City of University City, Missouri

Lewis Park – Needs Assessment Study

Final Concept Master Plan

REVISED August 23, 2013

**FINAL OVERALL
CONCEPT MASTER PLAN**
Scale: 1" = 30'-0"

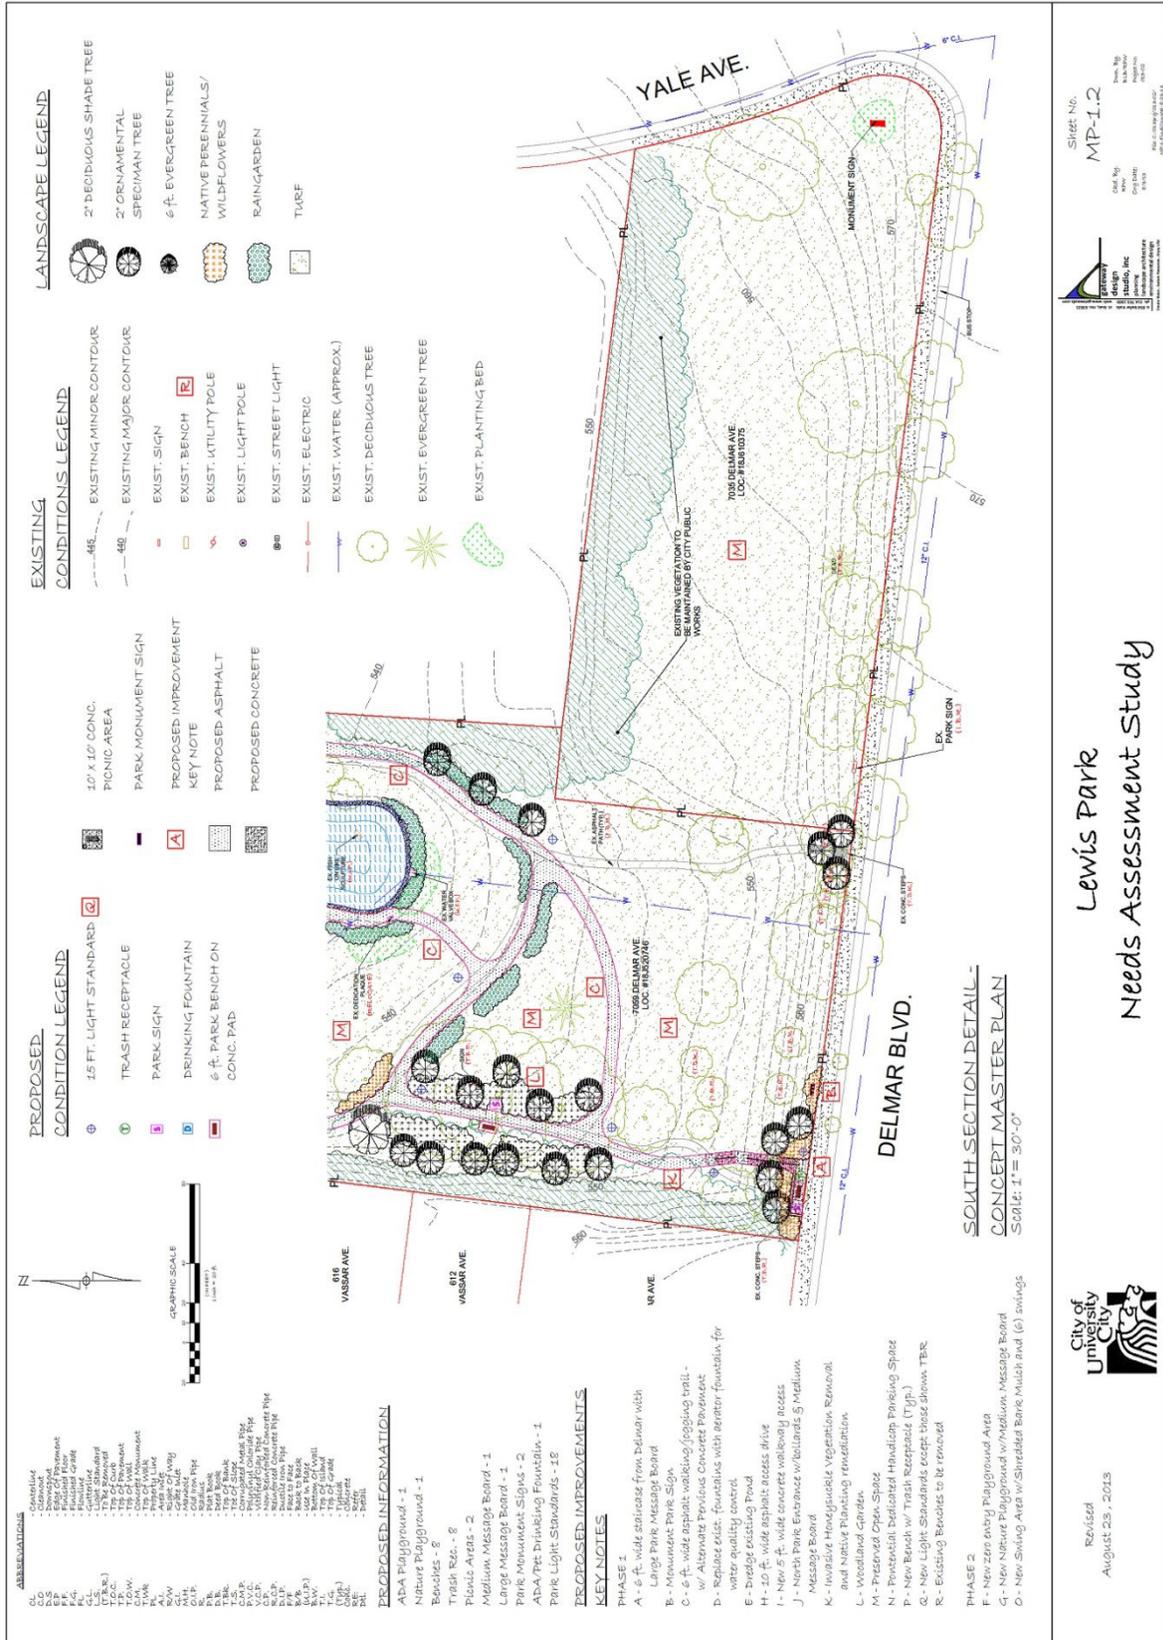
3. Some comments which were provided by the residents are as follows;
 - a. No staircase or ADA ramp from Delmar is desired.
 - b. More planting is good and encouraged.

- c. Proposed 10 ft. wide walkway is too wide and should be reduced.
 - d. Any planned or future parking was strongly rejected by the residents.
 - e. It was suggested that ADA access be from the north entrance and from the east connecting walk from University Heights.

- f. Any planned or future gazebo or shelter was strongly rejected.
 - g. Sledding on the hillside from Delmar is a long and a multi-generational tradition of the neighborhood. No improvements are to disrupt the ability for children and families to use the hill in the winter time for sledding.

- k. Storm water runoff is an issue and should be addressed by plantings and rain gardens. Specifically the area around the playground will get swamped. On some occasions during heavy rains, the pond has overflowed despite the fact it has an overflow structure.

- l. The pond water quality is in poor condition and needs to be improved and better maintained. There was some concern regarding the depth of the pond and the potential for persons to fall in and drown. However, it was noted that the pond will be re-graded to allow for a ledge around the edge for safety reasons should someone fall in. Generally water level needs to be a minimum 4 ft. deep to prevent algae and plant growth to occur within the water feature.

- m. More swings are desired for babies and older kids.
 - n. There was discussion regarding the importance of adding direction signage along Delmar to clearly designate where people can park along the street and enter the park.

- o. The northeast corner entrance to the park from University Heights walkway needs to be improved.
 - p. A ramp from Delmar along the southwest property could be considered and studied.

4. Further comments from the Residents were as follows;
- a. The dedicated HC parking space may be an issue and the City will have to discuss with the subdivision trustees for approval.

- b. Pervious concrete as an alternate was suggested for the trail.
 - c. The use of rubber mulch was strongly rejected.
 - d. Every effort to minimize toxic contamination should be planned as part of the future development of the playground area.

- e. Playground area should be flexible in size and uses.
 - f. A half circle amphitheater was suggested south of the playground area for gatherings.
 - g. Investigate alternatives to the rubber surfacing for playgrounds.

- a. GDS to remove any reference to a future parking lot and drive.
 - b. GDS to remove any structures such as gazebo, shelters or bathrooms.
 - c. GDS to provide a 5 ft. wide stair access to the park from Delmar at the southwest corner of the site.

- d. GDS to provide (2) baby swings for the swing area within the playground.
 - e. GDS to look at Flynn Park as an example for a climbing structure as part of the playground area.

- f. GDS to provide (2) aerator fountains on the plan replacing the older ones as part of improving the ongoing maintenance of the water quality.
 - g. GDS to reduce the walkways to 6 ft. maximum width.

- h. GDS to depict on the plan a dedicated on street HC parking space by the north entrance. City is to confirm the ability to provide this parking space and signage in order to collaborate and gain approval with the residents in the neighborhood regarding this matter.

- a. A 6 ft. wide staircase from Delmar Blvd. sidewalk is now located at the southwest corner of the site. No ADA ramp is planned.
 - b. Additional planting was incorporated where possible.

- c. The proposed asphalt walkway was revised to 6 ft. width.
 - d. Any planned or future parking was eliminated from the plan.
 - e. ADA access will be from the north entrance and from the east connecting walk from University Heights.

- f. Any planned or future gazebo or shelter was eliminated from the plan.
 - g. No improvements are planned to disrupt the ability for children and families to use the hill in the winter time for sledding.

- h. Open space has been designed into the plan which is critical and in short supply. The open space area to the east will be preserved for unorganized activities such as soccer, Frisbee, softball, etc.

- i. Storm water runoff has been addressed with rain gardens throughout the park.
 - j. The pond water quality will be improved by replacing existing sprays will aerator fountain sprays and dredging to an acceptable depth to prevent vegetative growth.

- k. A swing set area of 6 swings has been proposed as part of the playground area.
 - l. A potential dedicated HC parking space was shown on the plan at Vassar Ave.

- a. GDS to include on the plan the Woodland Garden as part of Phase 1 improvements.
- b. GDS to include the honeysuckle removal along the west property as part of Phase 1 improvements.
- c. Only items to remain as part of Phase 2 will be the playground improvements.
- d. Plans and cost estimates are to be revised accordingly.
